NUREG-0046

# **environmental statement**

## **THE HUMECA URANIUM MILL**

**RIO ALGOM CORPORATION**

I-4  
Figure 3

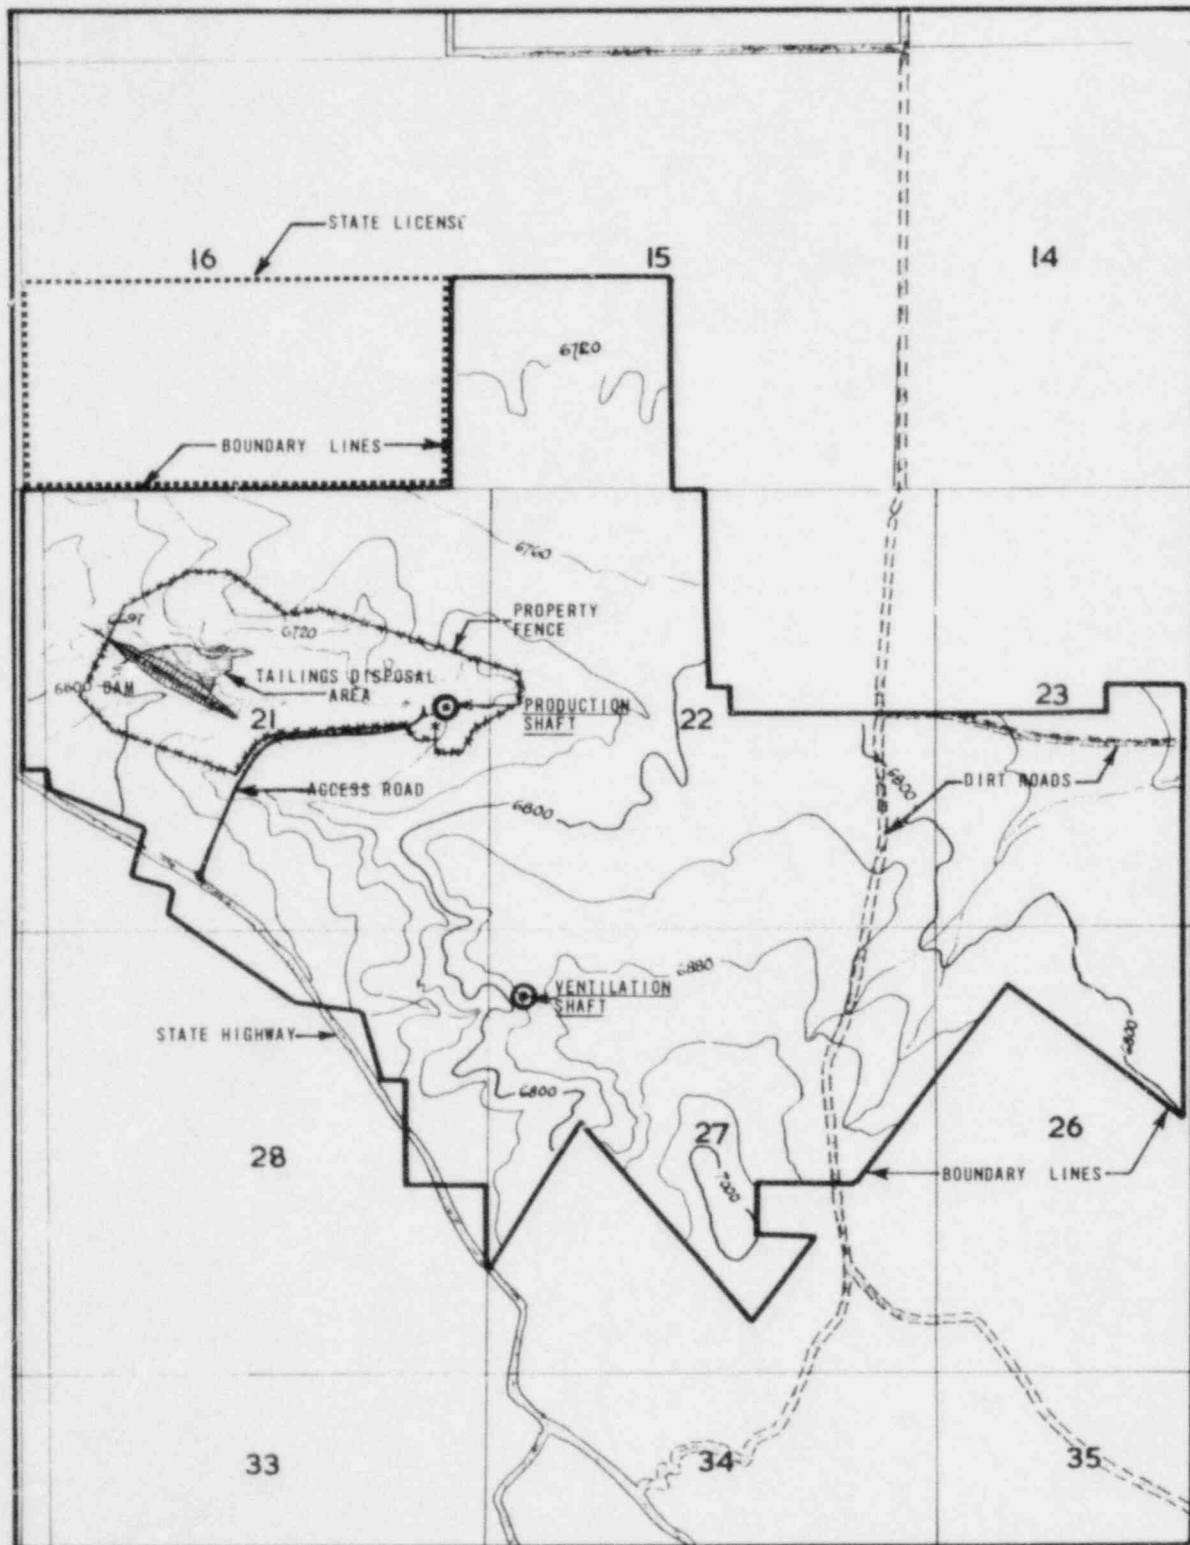
1. Page 7, third paragraph, states, in part, "The block of ground as indicated in Figure 3 which contains the mill and the tailings area will be enclosed by a perimeter fence, 3'6" high wire fencing with 6" x 12" openings to prevent access by sheep and cattle..." This fence will not prevent access by deer and other wildlife. The 45 acre lake will be an attractant to waterfowl, waterbirds and other wildlife. What will be the effect on wildlife species once they get inside the fence, land on the lake, or drink the water or eat flora or fauna associated with the lake? T-29
